**SAFETY EVALUATION REPORT
REQUEST FOR RELEASE OF THE SINCLAIR FARM ANIMAL BURIAL SITE
FOR UNRESTRICTED USE PURSUANT TO 10 CFR 20.1402**

The staff evaluated the licensee's submittal to determine if Tract 7 meets the unrestricted release criteria and therefore that Tract 7 can be removed from MU license 24-00513-32.

Figure 2 Map of the Locations of Subsurface Samples of Tract 7. (samples from the grid pattern are shown in red whereas judgmental sample locations are shown in white with the letter 'J')

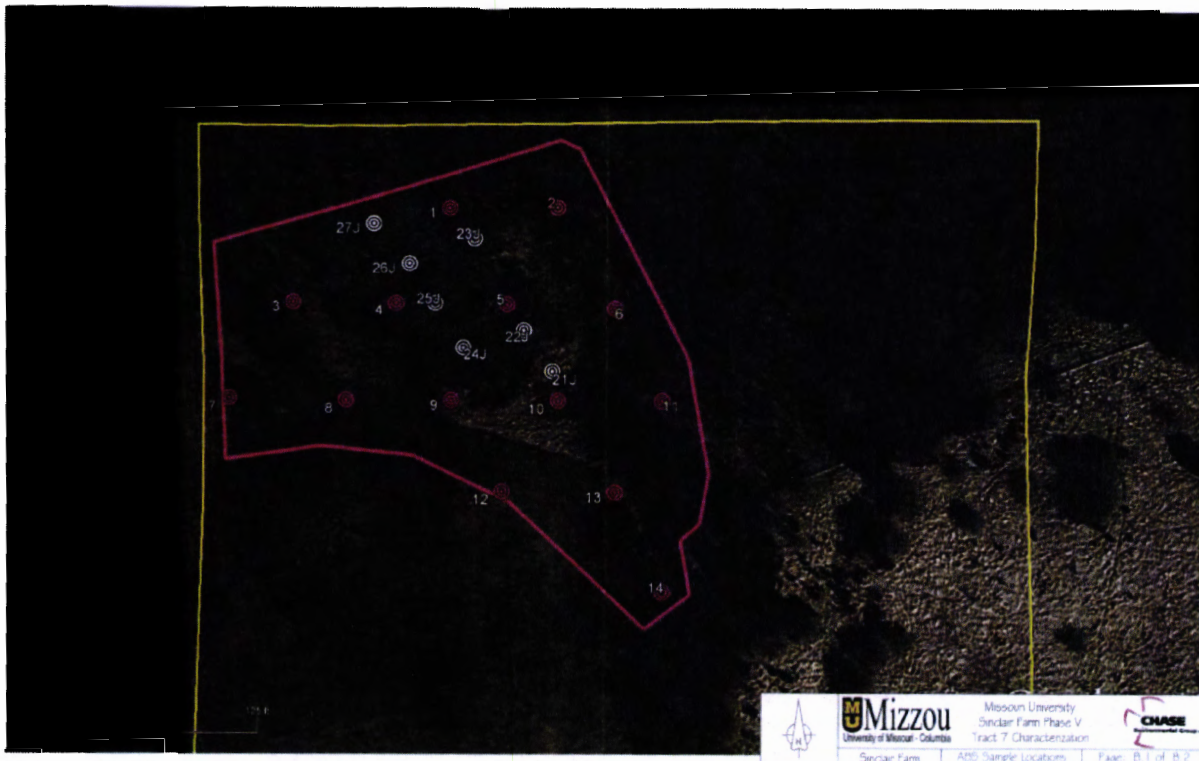
Staff evaluated the overall sampling approach as well as the specific sampling locations and results. Though the Multi-Agency Radiation Site Survey and Investigation Manual (MARSSIM) does not apply to subsurface soils, the licensee considered MARSSIM protocols in its sampling approach. As shown in Figure 2, the licensee used a sampling grid supplemented with judgmental locations. Most sample results were below the minimum detectable concentrations. For the ABS, there is no significant statistical or visual pattern in the observed concentrations of C-14 and H-3 with depth of sample. A higher fraction of the results that were above the minimum detectable concentrations were in the center of the sampled area than at the boundaries.
